REPORT TO THE
NUCLEAR REGULATORY COMMISSION

THE PACIFIC GAS AND ELECTRIC COMPANY

NUREG-0578:

"TMI-2 LESSONS LEARNED TASK FORCE
STATUS REPORT AND
SHORT-TERM RECOMMENDATIONS"

FIGURE 2.1.1-9
PRESSURIZER LEVEL
AND PRESSURE, SET 3

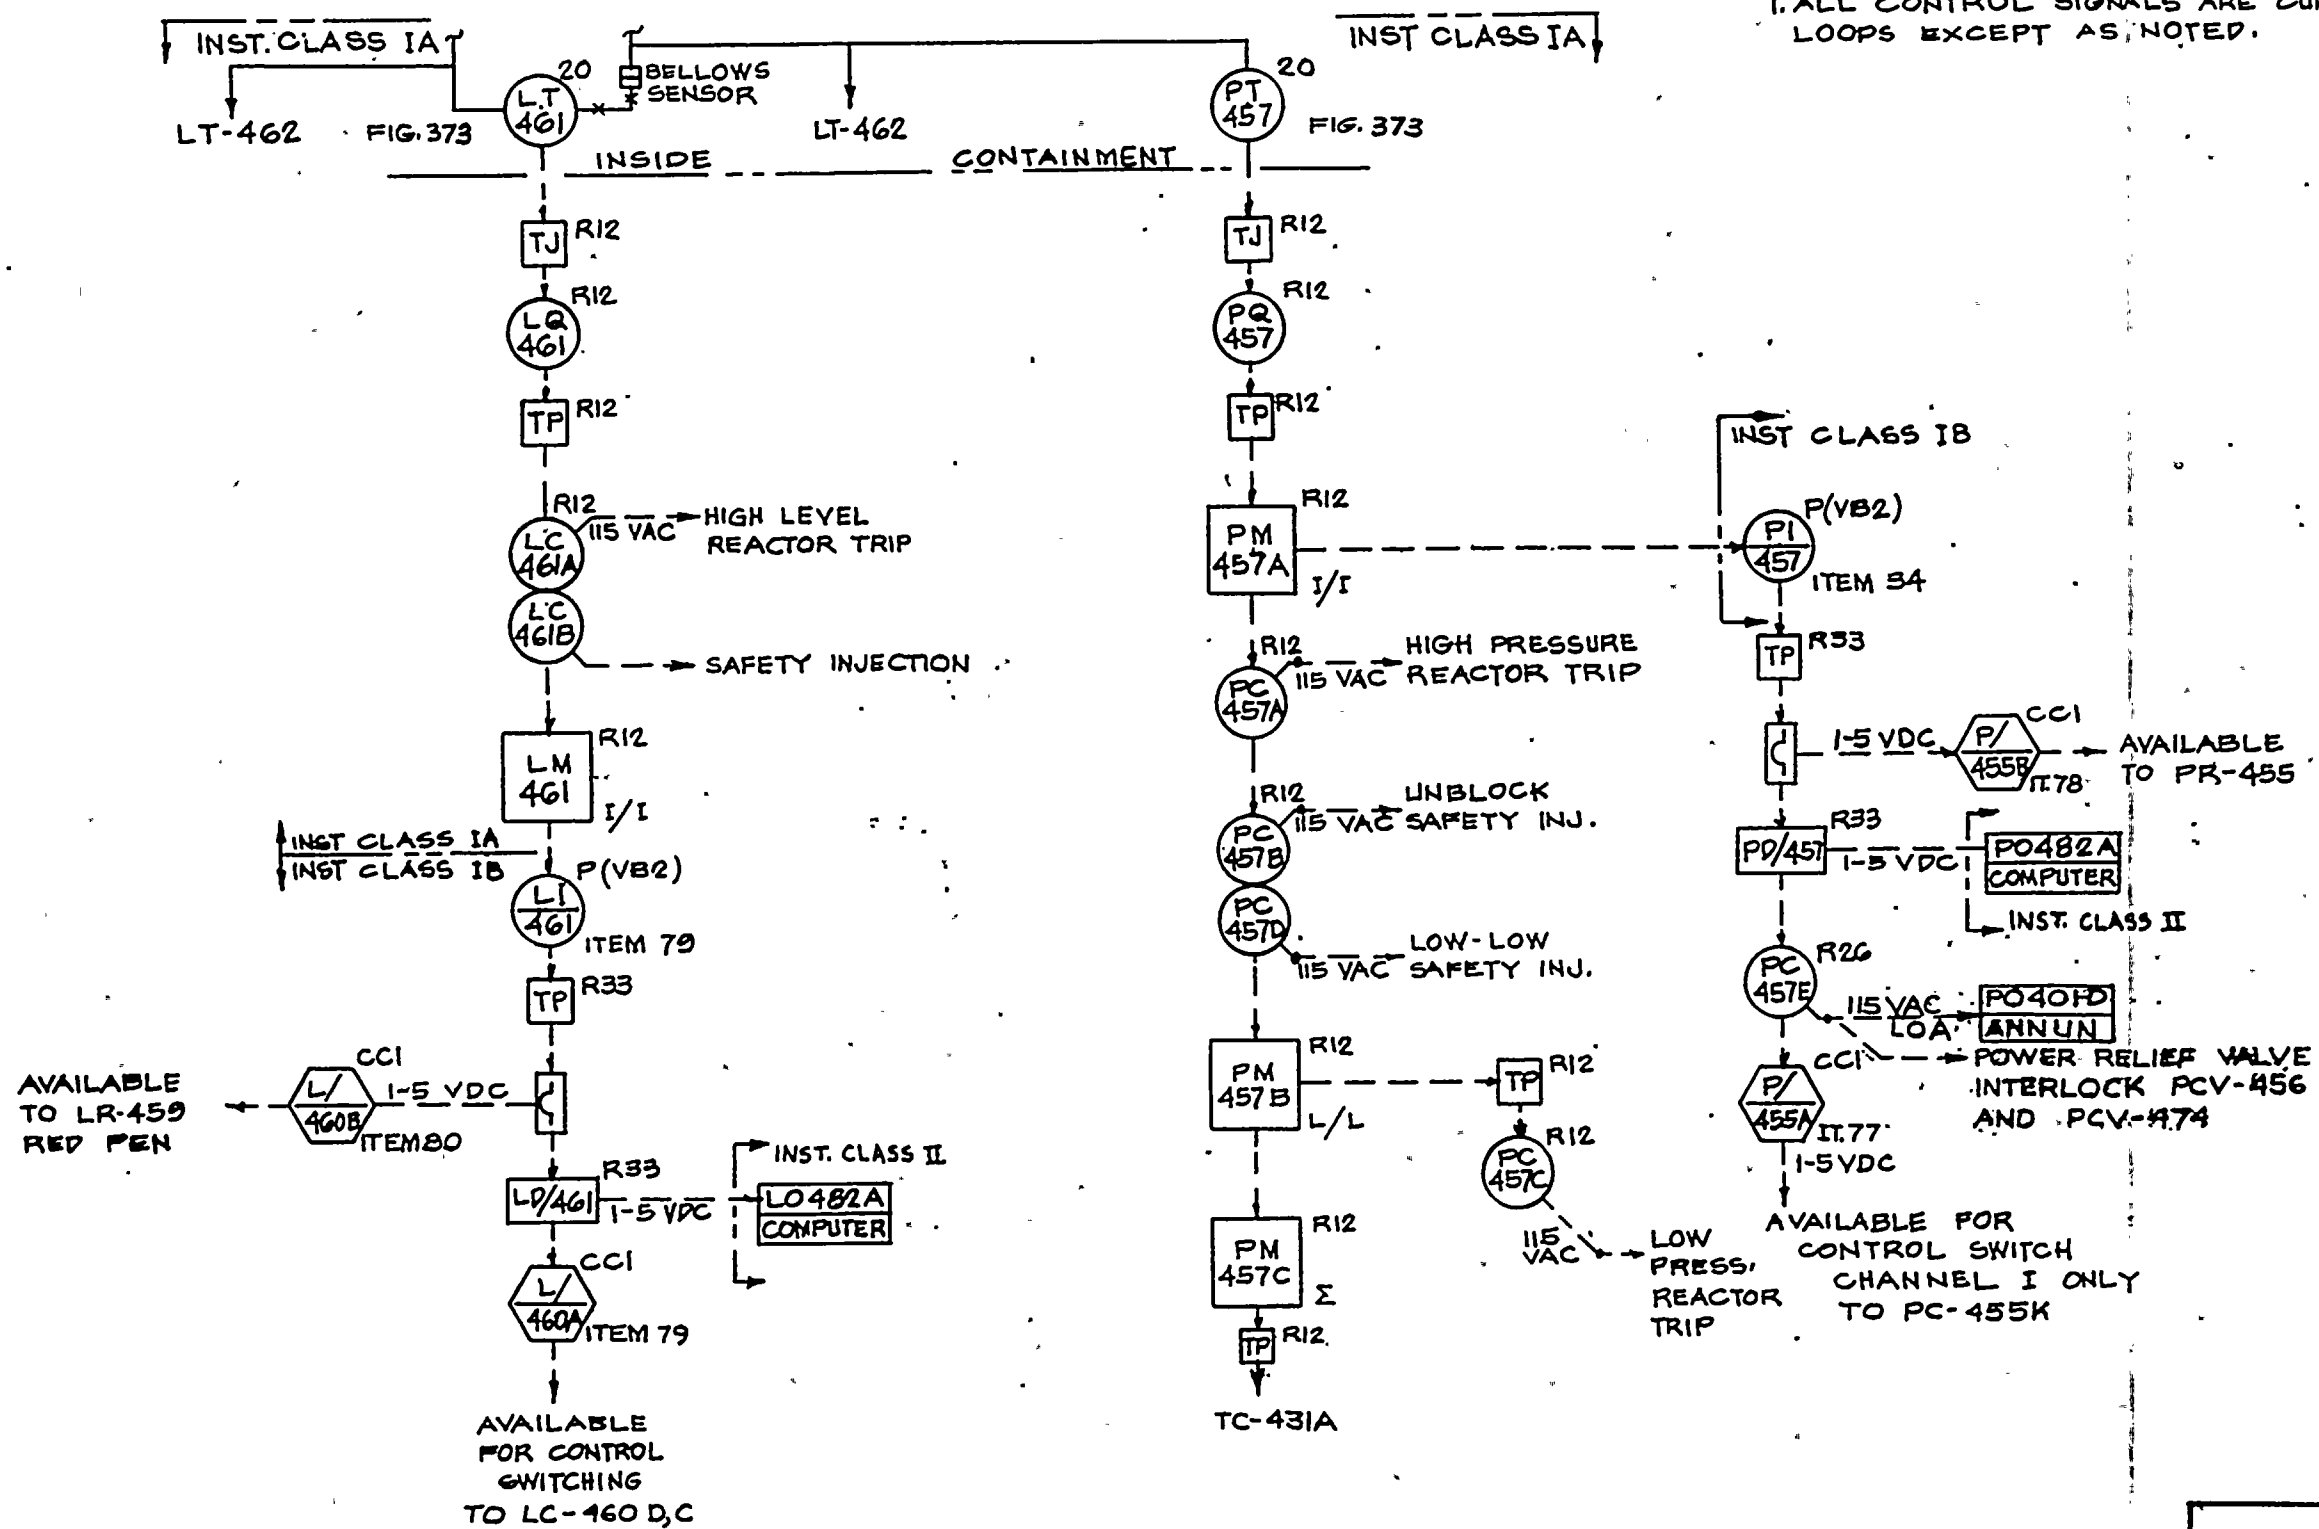
The pressurizer level indication instrument channels shall be powered from the vital instrument buses. These buses shall have the capability of being supplied from either the offsite power source or the emergency power source when offsite power is not available. (Category A: Implementation shall be completed prior to OL, or January 1, 1980, whichever is later.)

The pressurizer level indication circuits are safety-grade and post-accident qualified. AC power for all Class IE instrument channels is supplied from inverters which are supplied from the ESF buses with automatic backup from the emergency batteries (see Figures 2.1.1-4, 2.1.1-8 to 2.1.1-10).

UNITS 1 AND 2
 DIABLO CANYON SITE
 FIGURE 7.3-21 (Sheet 1 of 2)
 SCHEMATIC DIAGRAM - REACTOR COOLANT
 MOTOR OPERATED VALVES

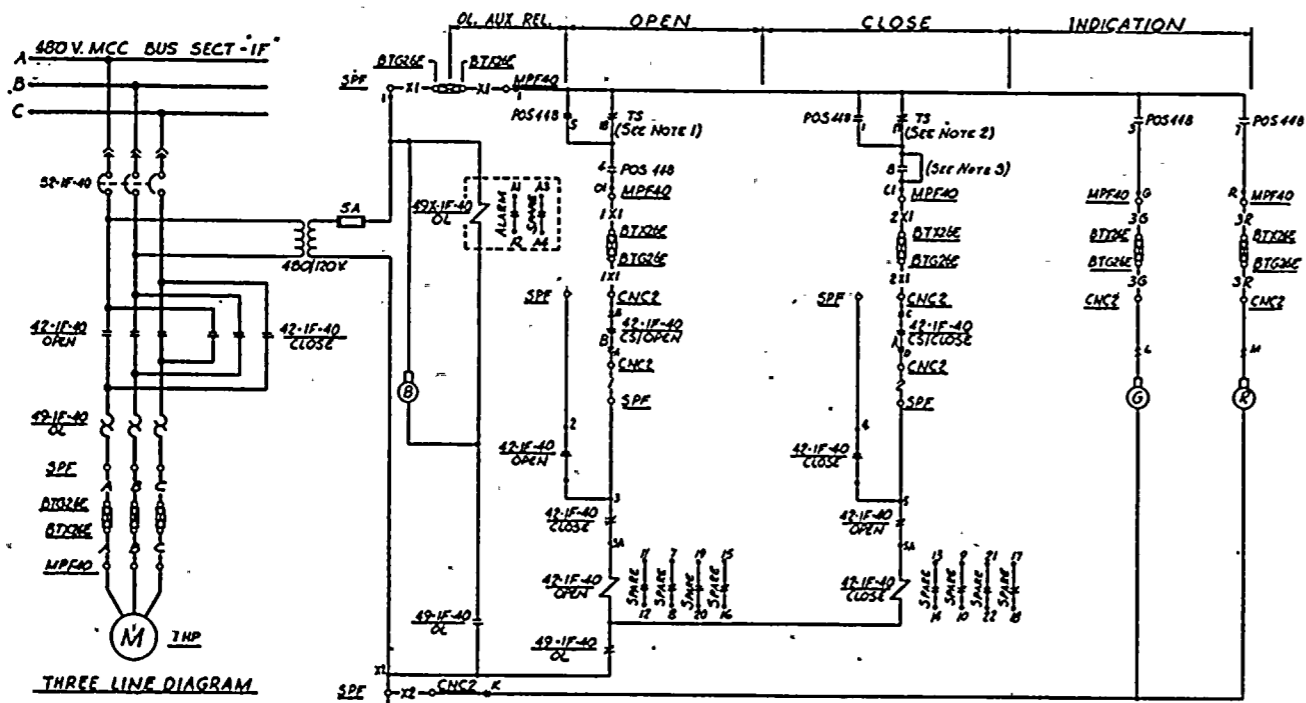
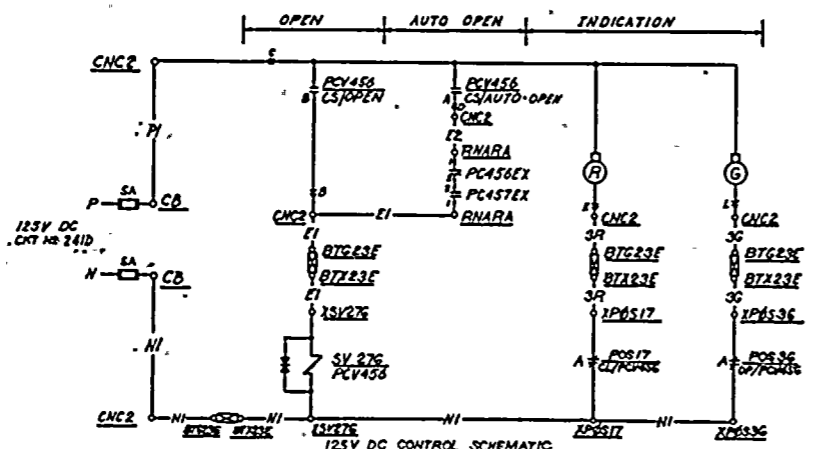
Reactor system relief and safety valves shall be provided with a positive indication in the control room derived from a reliable valve position detection device or a reliable indication of flow in the discharge pipe.

The pressurizer PORV's presently have both open and close limit switches which control indicating lights mounted at their respective control switches on the main control board. The limit switches are snap acting, positive throw switches mounted on the valve yokes. They are operated by the actual valve stem motion. The indication circuits are powered from the station batteries. All devices have been seismically qualified to meet the postulated Hosgri Earthquake. (See attached FSAR Figure 7.3-21, Sheet 1.)

FIGURE 3.2-03 (Sheet 2 of 4)
PIPING SCHEMATIC
FEEDWATER SYSTEM

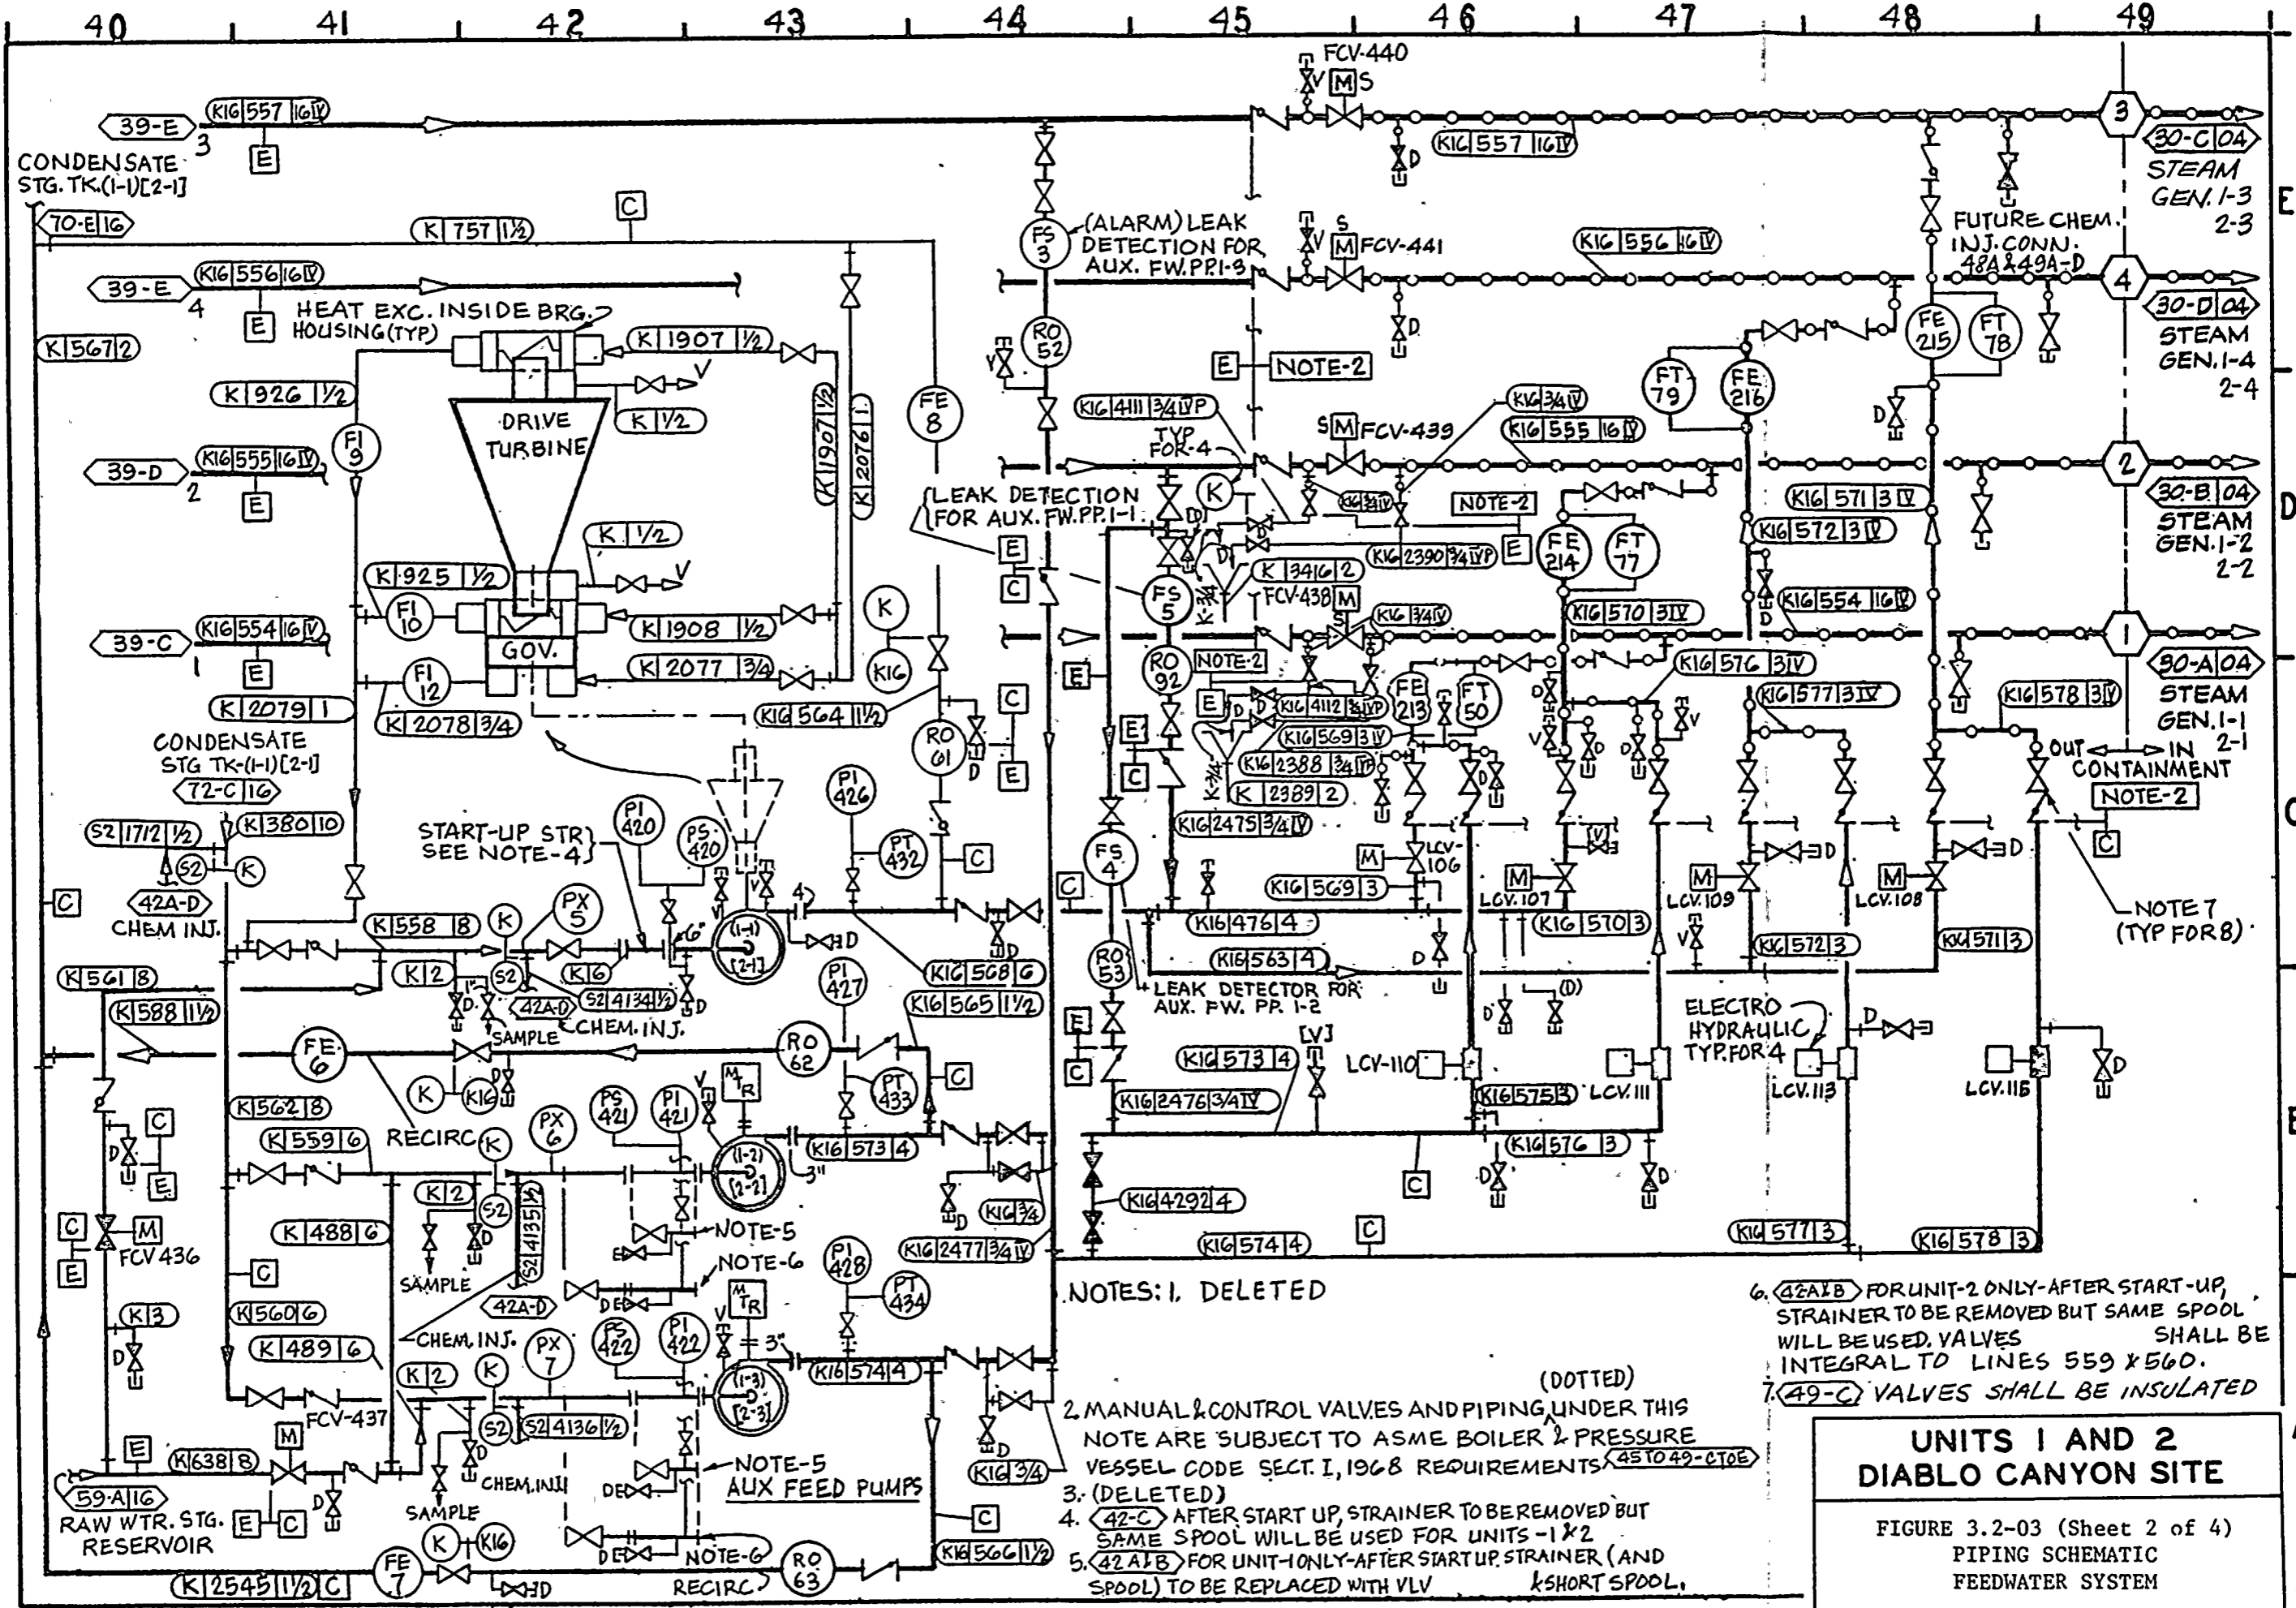
The design shall provide for the automatic initiation of the auxiliary feedwater system.

The auxiliary feedwater system is shown in the attached FSAR Figure 3.2-03, Sheet 2 of 4. The pumps are automatically started by low-low steam generator level, feedwater pump trip, safety injection, or station blackout. See attached FSAR Figures 7.3-8, 7.3-17, and 7.3-18. As shown on FSAR Figure 7.3-17, the motor-driven auxiliary feedwater pumps are started by closure of the Solid State Protection System (SSPS) output relay K633. Relay K633 is actuated by safety injection initiation or low-low level in any steam generator. Each pump is started by a separate relay from redundant SSPS trains A and B. The motor-driven pumps are also automatically started by trip of both main feedwater pumps.
